**PERMITTEE FLORENCE COPPER, INC.’s RESPONSE TO PETITION FOR REVIEW  
FILED BY THE GILA RIVER INDIAN COMMUNITY**

**Gila River Indian Community’s (“GRIC’s”) Comments on Draft Permit**

Re: Gila River Indian Community Comments on the Draft Class III  
Underground Injection Control Area Permit for the Proposed Florence Copper  
Project, Florence Copper Project Production Testing Facility, Florence, Pinal  
County, Arizona

**Subject: Florence Copper Project – Technical Aspects of the EPA Underground Injection Control Well Permit**

Figure 6 - One Year On, One Year Off - Uniform Hydraulic Conductivity - Particle Tracks

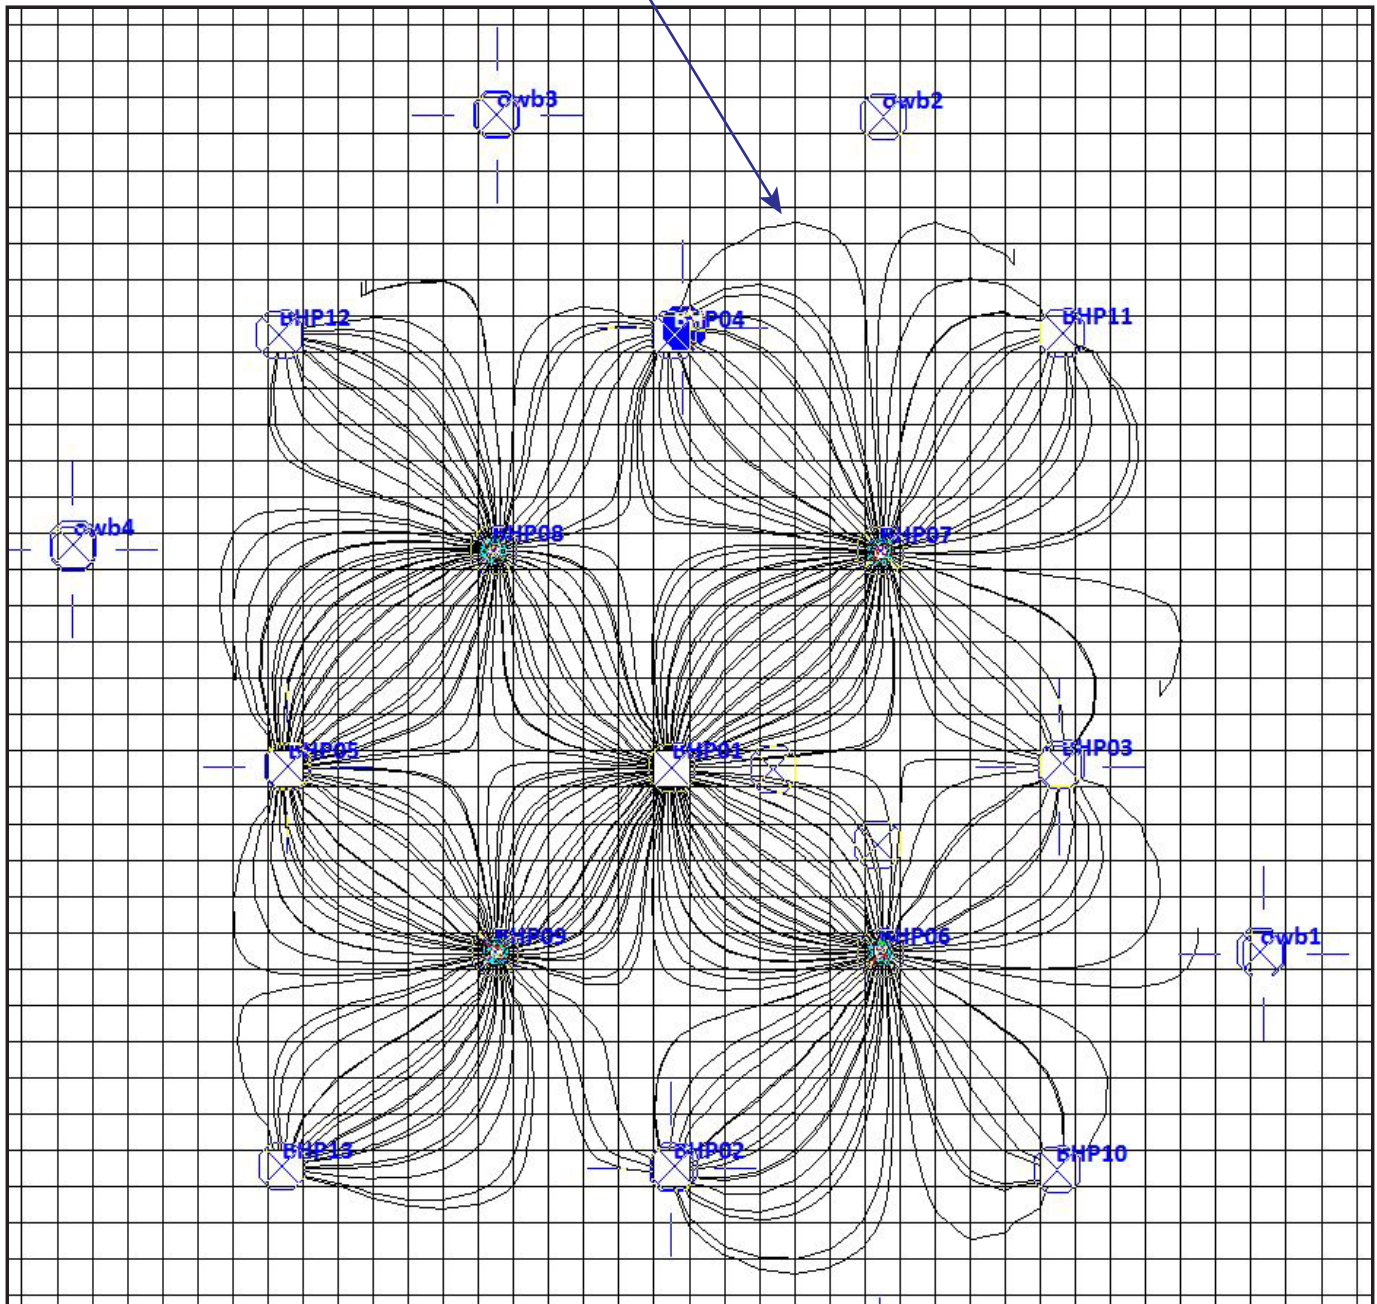
Two additional simulations were prepared to observe the effects of individual pumping rates. The rates during the official 90-day Pilot Test were extended for a year and then turned off. As extraction is continued, the particles were drawn around and back into the extraction wells. It appears that the observed spikes of low pH and elevated sulfate at some observation wells noted in the data by the Appellants could be explained by travel along the particle tracks similar to those simulated here for the test. There was more than a one foot inward water level difference between the locations of the extraction wells and the observation wells just outside when this escape was occurring. See Figure 6 for the simulated particle tracks resulting from the case of using a uniform K and extending the 90-Day BHP test rates for a year and then turning them off. The water particles not yet drawn into an extraction well when the system is turned off will eventually head away from the test wells with the background groundwater flow.

Particle Track escapes  
between extraction wells  
but is pulled back

Flows at wells are kept at rates used by BHP in "90-day test" (Nov. 97 to Jan. 98)

**Figure 7 - One Year On, One Year Off - Uniform Hydraulic Conductivity - Particle Tracks  
Move Half of Extraction on Downgradient Side to Upgradient Side**

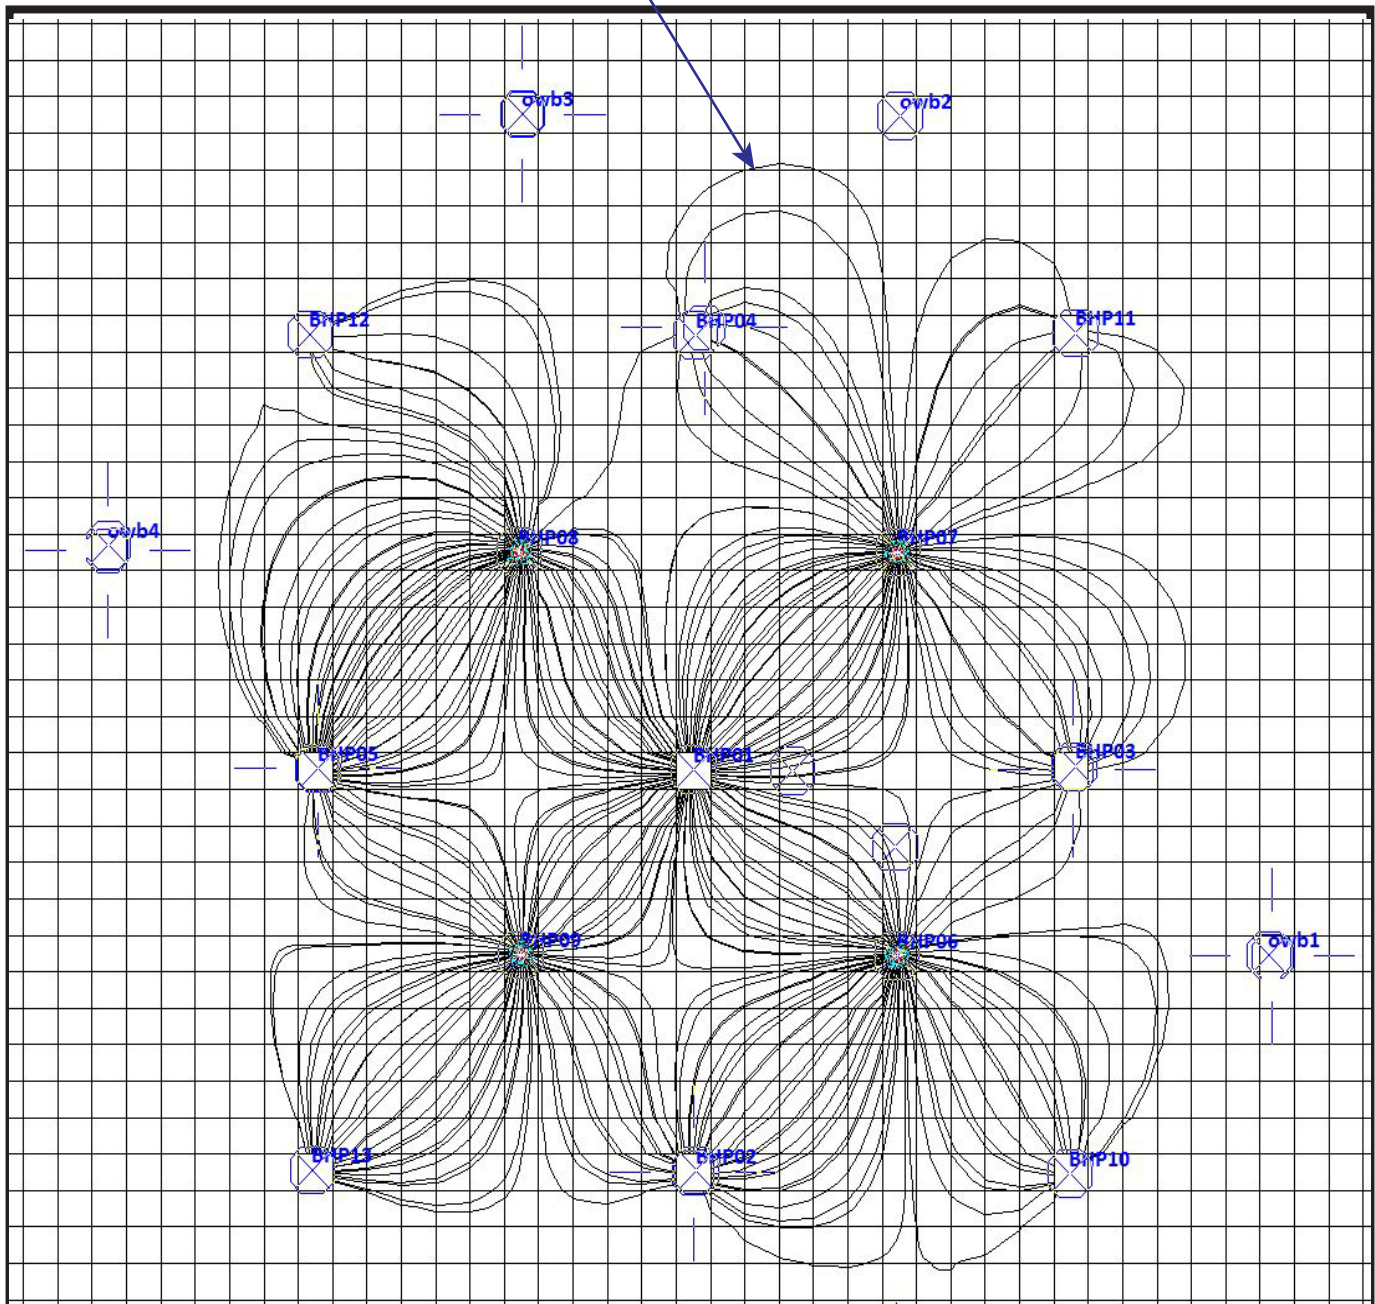
When the pumping rates for the three downgradient wells were decreased by half and these rates were added to the three upgradient extraction wells, the potential for drawing water back into extraction wells was more evident in that particles proceeded farther down gradient between the extraction wells, but were eventually drawn back in. Again, there was more than a one foot water level difference between the locations of the extraction wells and the adjacent observation wells. See Figure 7 for the simulated particle tracks resulting from the case similar to that of Figure 6, but with half of the pumping at the downgradient extraction wells transferred to the upgradient extraction wells.

Particle Track escapes farther  
between extraction wells  
but is pulled back

Flows at wells are kept at rates used by BHP in "90-day test" (Nov. 97 to Jan. 98)  
Except to cut rates in half at downgradient (top of picture) extraction wells and  
add those amounts to the upgradient (bottom of picture) extraction wells  
(Total pumping remains the same for injection and extraction)
